RESULTS OF WRITTEN EXAMINATION PERFORMANCE ANALYSIS

Excerpt from the Westinghouse print 1082H70-1

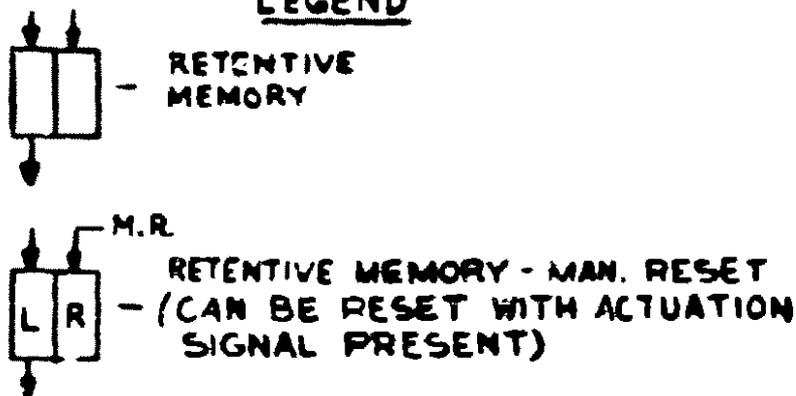
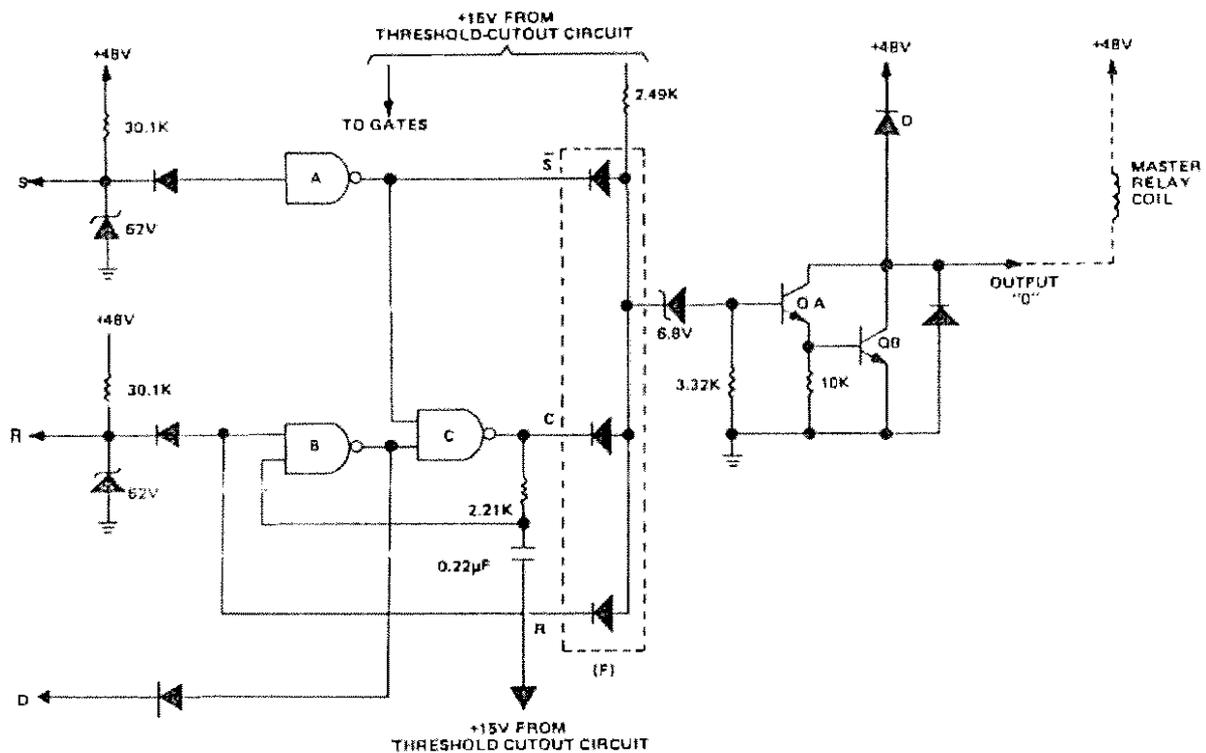
When the utility representatives modified this question in Atlanta, they failed to realize that the ON/OFF retentive memory affiliated with the Phase A isolation signal will change to the OFF state with a safety injection signal present.

Inspection of the Westinghouse print 1082H70-1 reveals a key detail not contained in the TVA logic prints. This content is that the retentive memory affiliated with the Phase A containment isolation is able to be reset with the actuation signal present. This type of retentive memory is depicted by the use of the L and R designators.

Question 55 asked the applicants to consider whether the Phase A containment isolation could be reset if its initiating signal had NOT been reset. Given the aforementioned circuit design, the correct answer should be that it could. Therefore, the keyed answer to question 55 should be A.

The facility recommends changing the answer to question 55 to A.
